RTCA Special Committee 209

Mode S Transponder MOPS Maintenance

Details of Suggested Change to Figure 2-19 in DO-181D

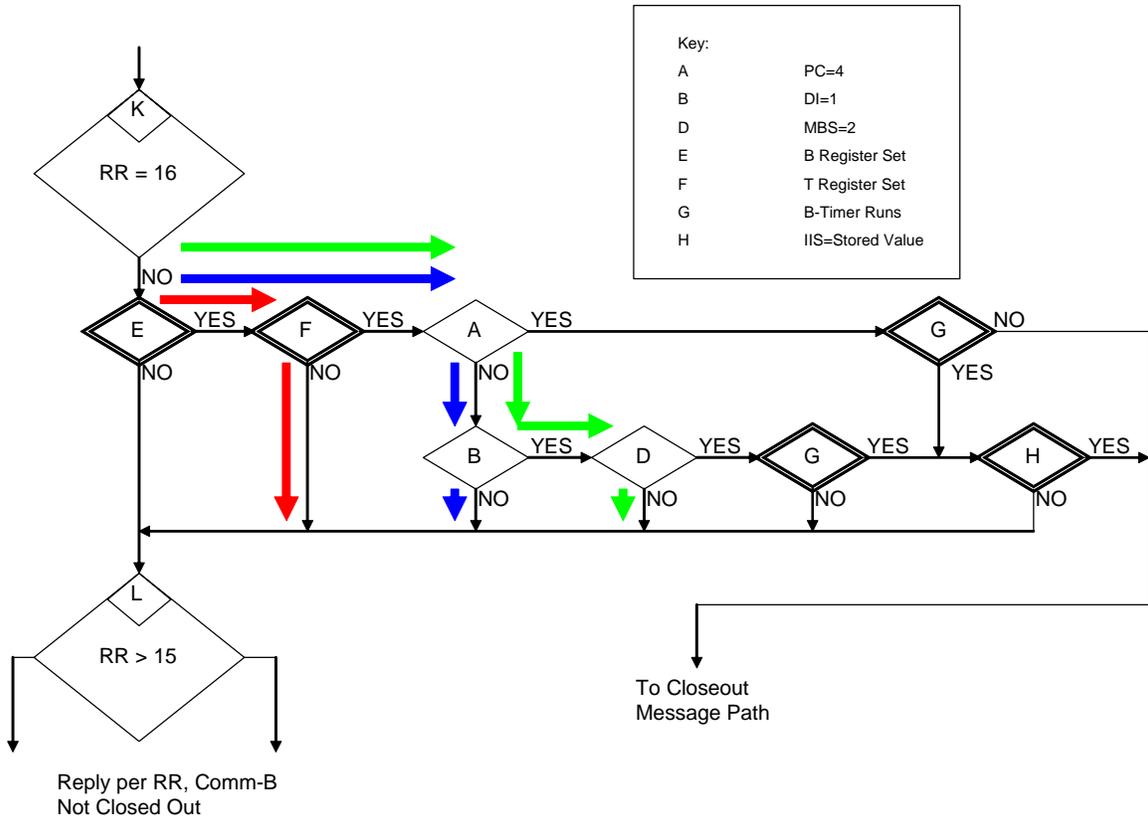
I have been reviewing and updating figures for DO-181 and of course this includes our favorite Figure 2-19. Recently I pointed out a problem with our latest change to this figure that you seemed to concur in your response pending further review. I have included detail here that identifies this problem and makes a case for adopting my original proposed correction (ModeS-WP01-06). I have tried to just make adjustments to the current figure to resolve this but there isn't a simple change that works. It is my position that my proposed change is efficient as possible and correct. The attached paper presents my case.

The following series of figures shows that the correction to Figure 2-19 originally proposed in ModeS-WP01-06 correctly processes all possible transponder states and interrogation patterns.

The section of the flowchart that is in question has two possible outcomes: to closeout a Comm-B message or not. The first figure shows that if basic conditions for closeout are not met, that closeout will not occur.

The **RED** path is taken if the Comm-B message was not transmitted at least 1 time.

The **BLUE** path is taken if the interrogation does not include closeout protocol (PC≠4, and DI≠1).

The **GREEN** path is taken if a multisite interrogation does not include closeout protocol (DI=1 but MBS≠2).
